# Work Order ID 96467

Item Name: 205 Bent Tube

DRAWING NO. D2580	TITLE 205 SKIDTUBE ASSEMBLY	REV. E	DART AEROSPACE LTD ENGINEERING ORDER		D.E.O. NO. D2580-E-1	SHEET NO. SHEET 1 OF 1	SCALE NTS
DRAWN <i>UP</i>	CHECKED <i>ASS</i>	MFG. APPR. <i>EC</i>	APPROVED <i>[Signature]</i>		DE APPR. <i>[Signature]</i>		
DATE 11.12.13	DATE 11.12.13	DATE 11.12.13	DATE 11.12.13		DATE 11.12.13

CHANGE ALL C'BORED WELDED CROSSBOLT SPACERS TO SWAGED SPACERS

**SECTION B-B, F-F, I-I**  
NOT TO SCALE

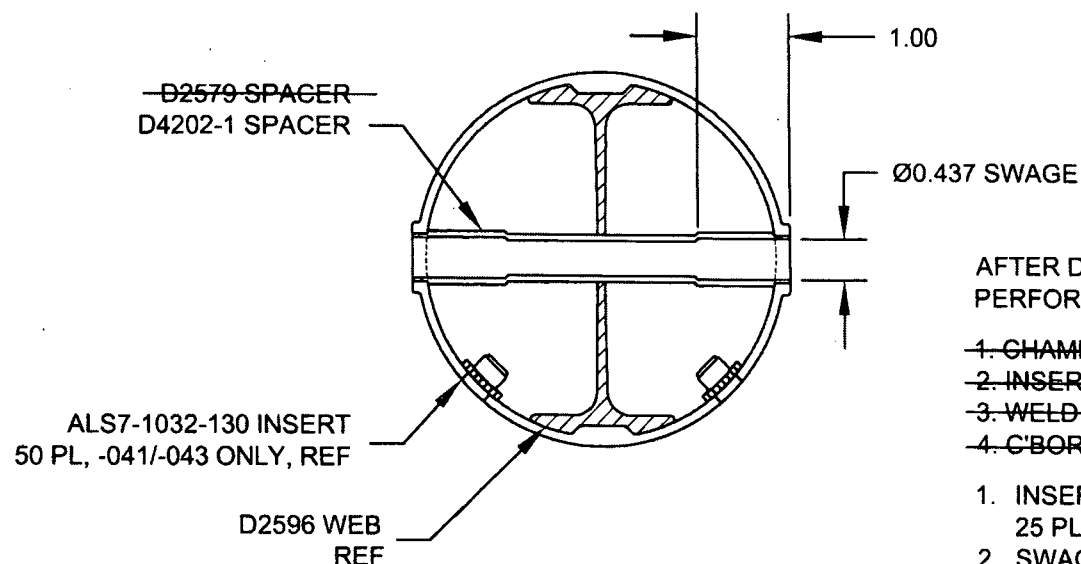
SECTION B-B, SECTION F-F, & SECTION I-I ARE AMENDED AS FOLLOWS  
FOR ALL HOLES THAT WERE ORIGINALLY C'BORED:

AFTER DRILLING AND BENDING ASSEMBLY  
PERFORM THE FOLLOWING FOR Ø0.508 HOLES ONLY:

1. CHAMFER HOLE 0.050 X 45°
2. INSERT D2579 SPACER (20 PLACES)
3. WELD INTO PLACE AND GRIND FLUSH
4. C'BORE D2579 SPACER TO Ø0.437 X 1.00 DEEP

4		* D2579	CROSS BOLT SPACER
20	20	25	D4202-1	SPACER

WELD 4X D2579 SPACERS PER DWG  
IN LOCATIONS MARKED "NO C'BORE".  
REF SHEET 4 OF DWG.

1. INSERT D4202-1 SPACER, 20 PL (-041) OR 20 PL (-045) OR 25 PL (-047)
2. SWAGE TO Ø0.437 X 1.00 DEEP PER QSI 002
3. TRIM / GRIND FLUSH PER QSI 002
